REMARKS:

This amendment corrects an ambiguity found during a final review of this allowed application. Changes to the specification and drawings seek to clarify that the first voltage follower is comprised of first differential amplifier 118 and voltage divider 108, the second voltage follower is comprised of second differential amplifier 128 and output stage 122, and the feedback paths of the first and second voltage followers.

FIG. 1

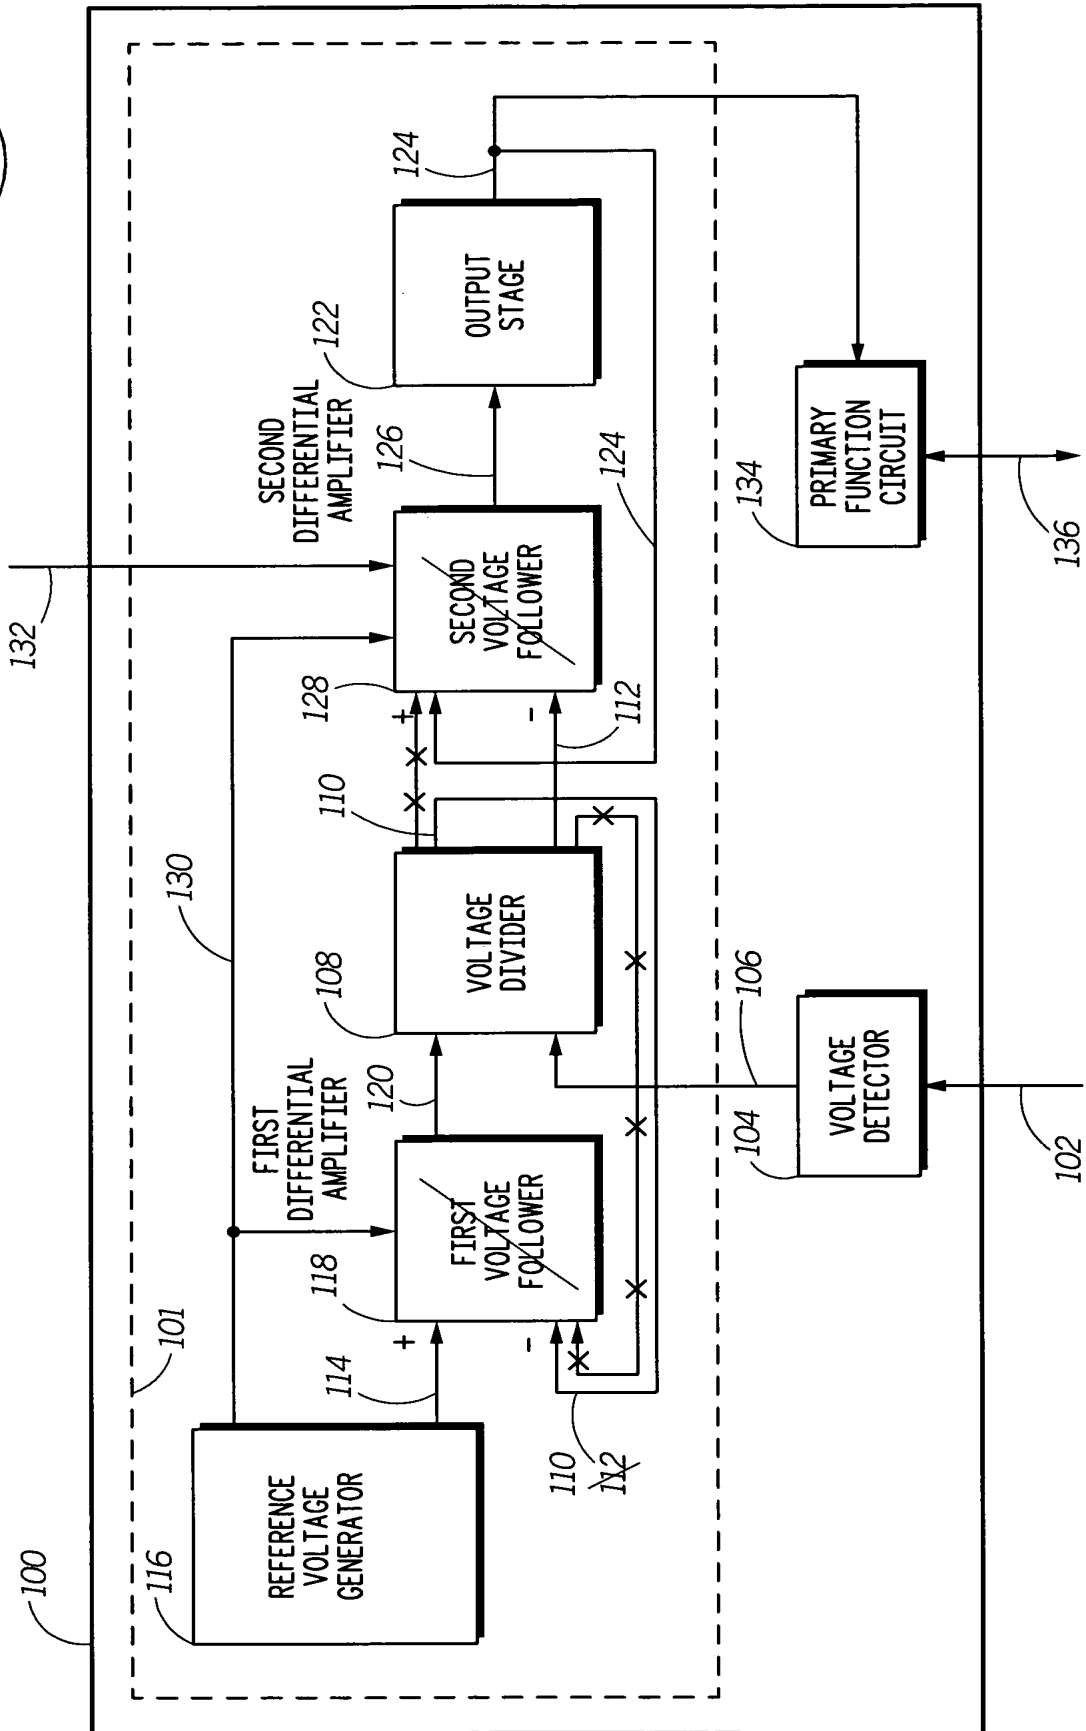
One of ordinary skill in the art would understand that circuits 118 and 128, shown in Figures 1, 3 and 5 as originally filed and described, are differential amplifiers and not voltage followers. Moreover, it is known that the combination of a differential amplifier circuit with a voltage divider circuit, shown for example in the original drawings as blocks 118 and 108, forms a voltage follower. The amendment to the specification simplify clarifies this.
